**ADDENDUM #2**

**TO CONTRACT DOCUMENTS FOR:** Project #CP262031 – Memorial Stadium West Bleachers Improvements - Renovations

**PREPARED FOR:** The Curators of the University of Missouri

**CONSULTANT:** Structural Engineering Associates, Inc.  
1000 Walnut Street, Suite 1570  
Kansas City, MO 64106  
(816) 421-1042

**7 TYPICAL EXPANSION JOINT DETAIL**  
1" = 1'-0"

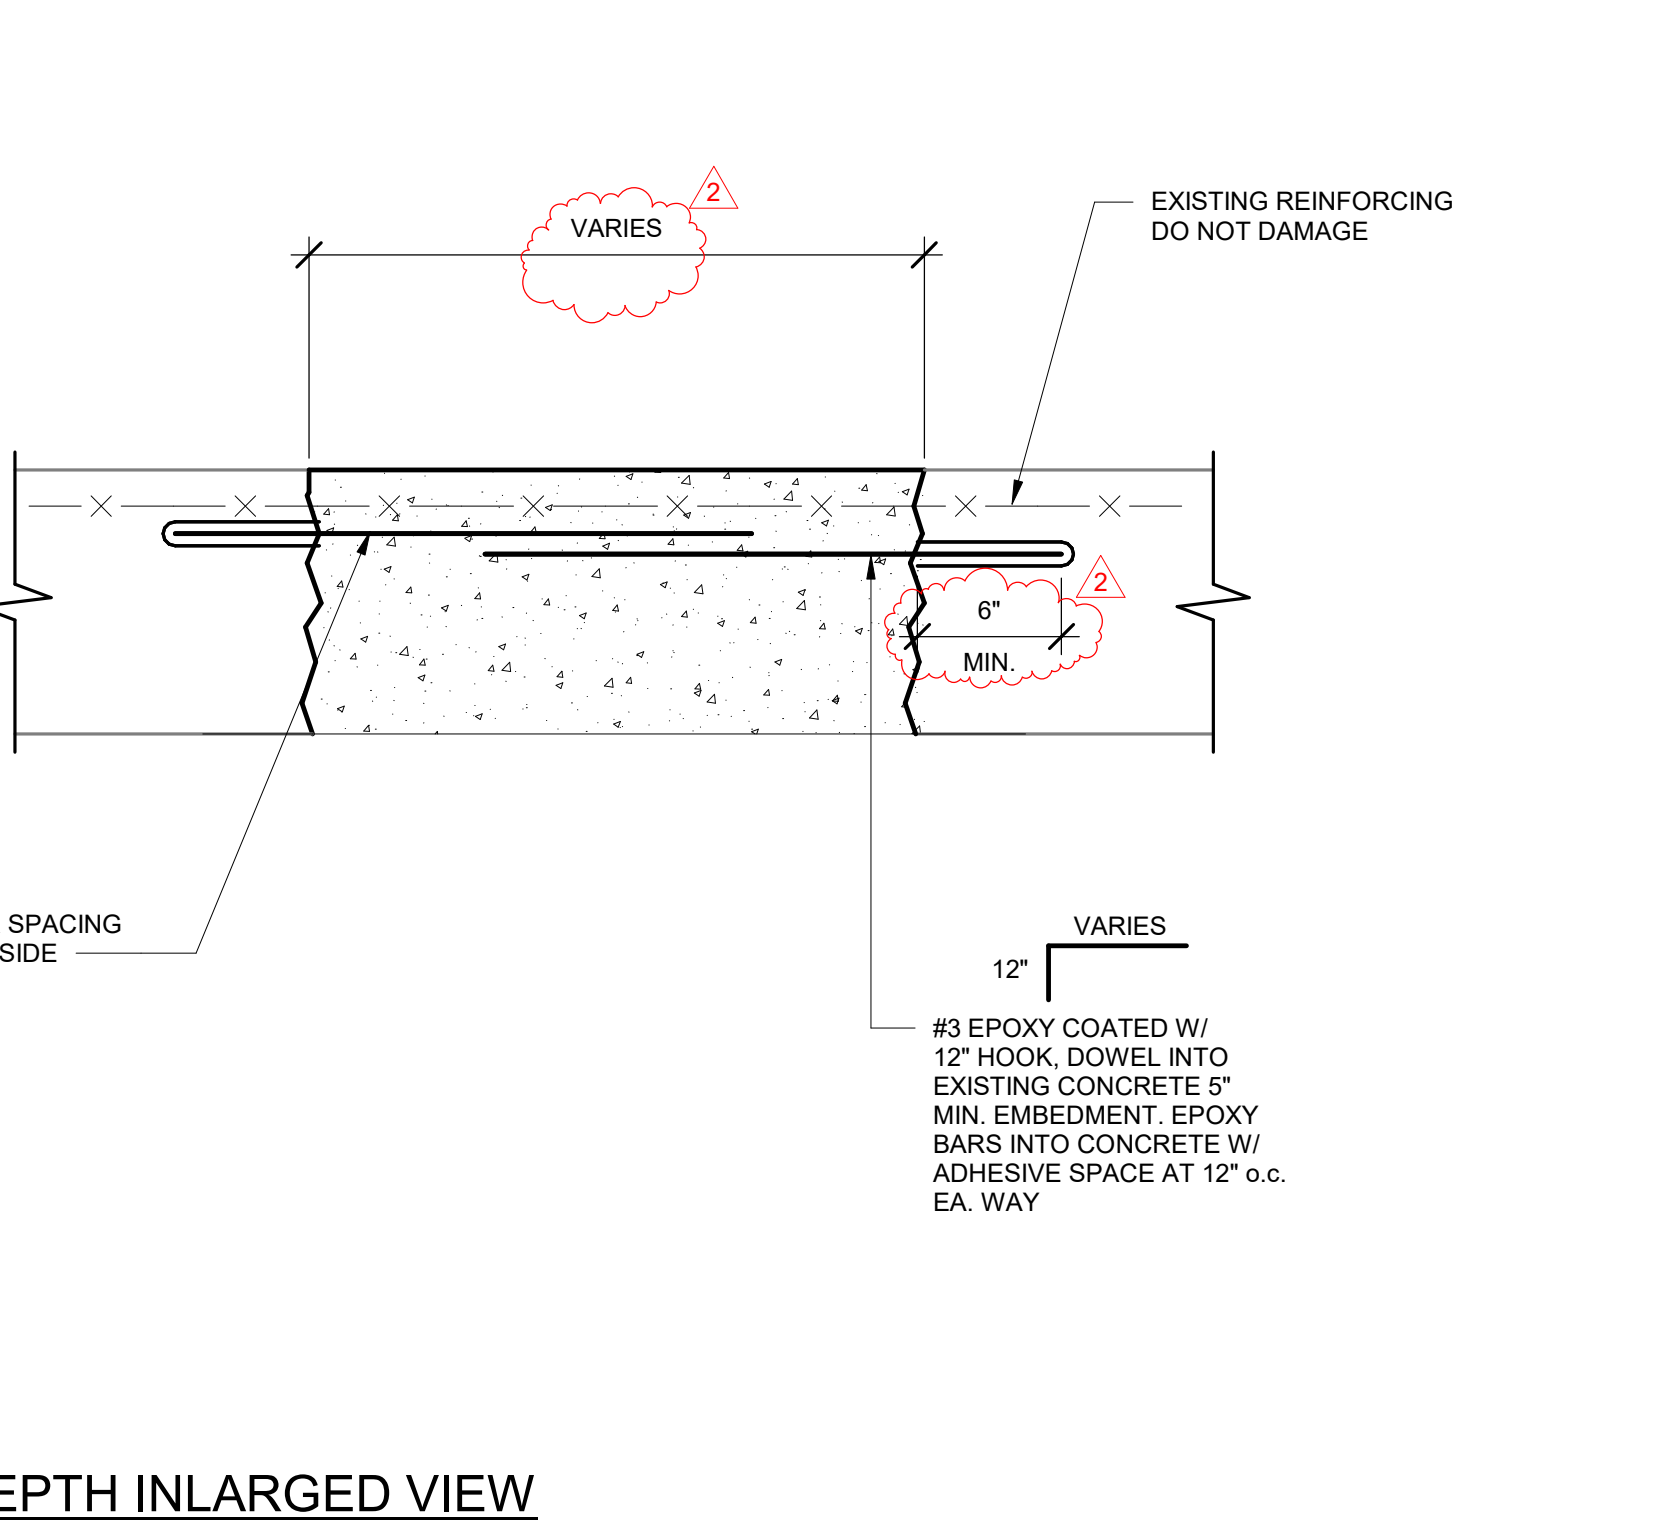
- 1) **Questions and Answers**
- a. Q) Regarding work item R-7, of the 2,400 LF included in the bid amount, what are the approximate quantities for the control, construction, and expansion joints being replaced? There is a significant price difference between the three.

- 1) Drawing Sheet S000, General Notes and Repair Schedule: **Replace:** “Expansion and Control Joints” from Repair Item R7. **Add:** Detail 7/S-002, **Change Units:** 200 LF for 2” or wider sealant joint, 400 LF for 1” or smaller sealant joint. Replace sheet in its entirety with attached sheet.

- 4) Drawing Sheet S000, General Notes and Repair Schedule: **Add:** Details to R10.
- 5) Drawing Sheet S-002, Details: **Change:** Detail 6 and **Add:** Detail 7.

A) Quantities have been divided to show quantities. See Addendum No. 2.
  - b. Q) Regarding work item R-9, the specification references a pedestrian traffic system. However, the Neogard system that is listed is the vehicular membrane system. Which Neogard pedestrian membrane system should be included in our pricing?

**4 TYPICAL STONE ANCHOR INSTALLATION**  
N.T.S.

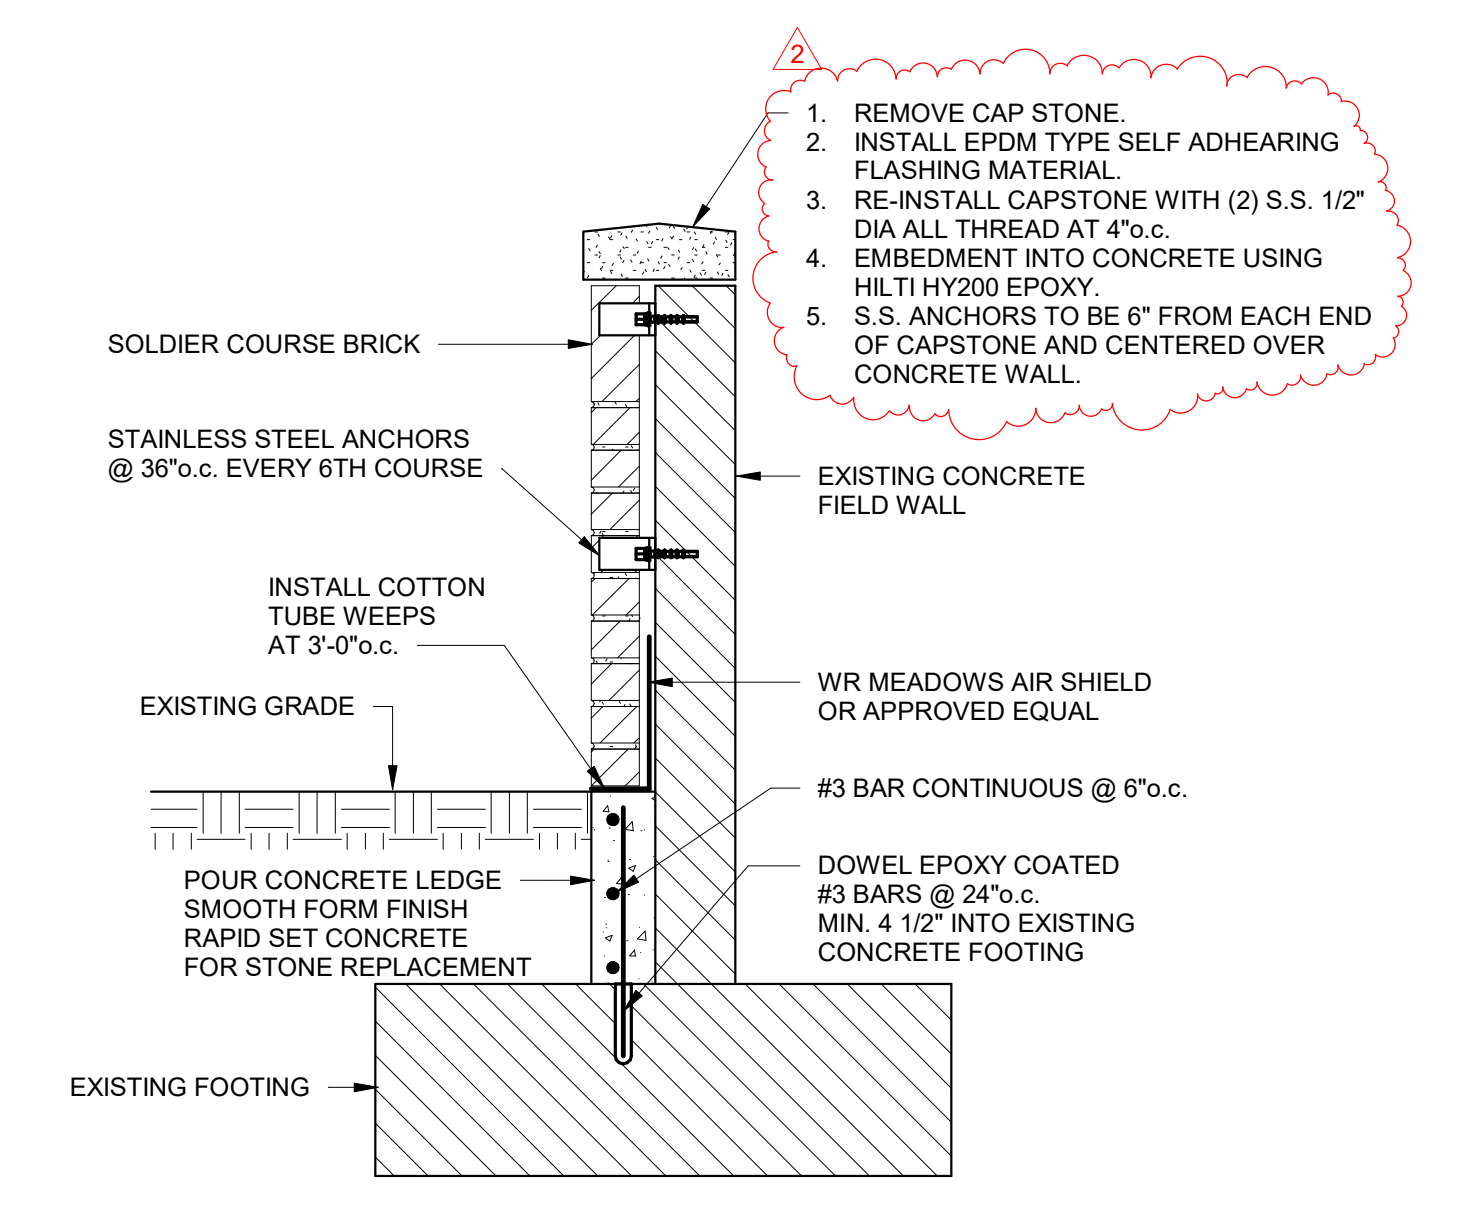
- o.** Q) Regarding detail 4/S-200, the detail does not show dowelling in of the capstone to the top of wall when re-installed. Also, no counterflashing at the top of wall is shown. Please verify that neither of these are required for this work.

- 7) Drawing Sheet S-200, Detail 4/S200: **Add:** “Notes for Sub-flashing and Capstone Installation”. Replace sheet in its entirety with attached sheet.

A) Yes, these are required. Detail will be corrected in Addendum No. 2.
- p.** Q) Regarding detail 4/S200, the detail is not to scale so Contractor does not know how far the excavation goes or how tall the new ledge is. Please provide an assumed depth to top of footing since this is an unknown buried condition.

24 EXISTING CONDITION PHOTO  
12" = 1'-0"

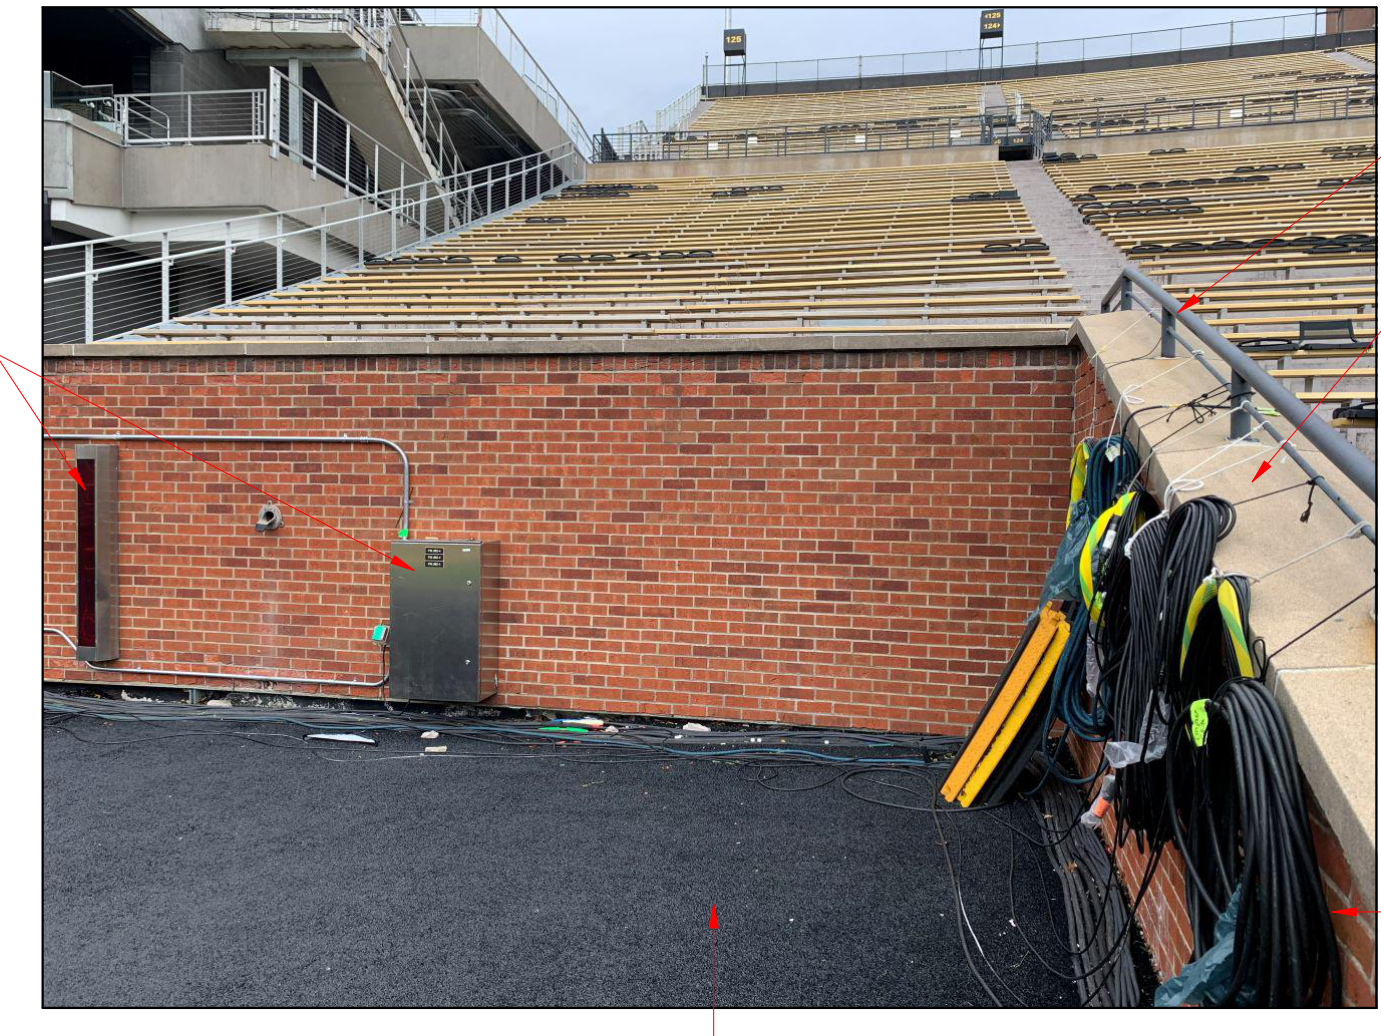
- 8) Drawing Sheet SP-101, Existing Conditions Photos: **Add:** “Detail 24” replace sheet in its entirety with attached sheet.
- 9) Drawing Sheet SP-101, Existing Conditions Photos: **Add:** “Detail 25” replace sheet in its entirety with attached sheet.
